# **VALUE ALTERNATIVE 10.0 (PE-4)**

## Use independent alignments for northbound and southbound directions

## **VALUE ALTERNATIVE 11.0 (PE-6)**

## Incorporate tunnel maintenance structure into tunnel structure

Use of independent alignments to address environmental concerns

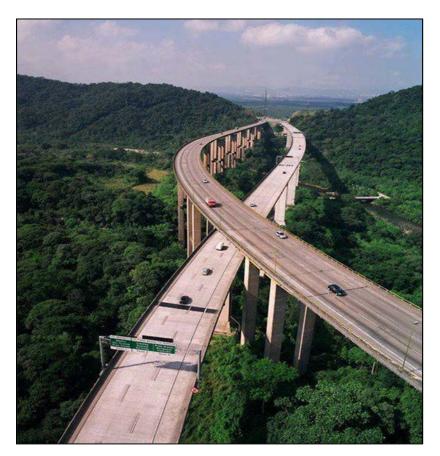
**Description of Alternative Concept:** The alternative concept would separate the northbound and southbound directions to reduce impacts to old growth trees.

- **Temporary Impacts** Increases construction time and complexity (requires two independent foundations).
- **Permanent Impacts** Increases overall project footprint. Increases impermeable surface.
- **Maintainability** Increases the amount of bridge structures to maintain. Reduces temporary traffic management flexibility. Reduces future traffic management flexibility.

**Discussion:** The main benefit of this alternative concept is to minimize the number (or specific) of old growth trees impacted by the alignment. The benefit of separate alignments is premised on achieving a reduction in the number of old growth trees that would require removal, or the avoidance of specific "high-value" old growth trees.
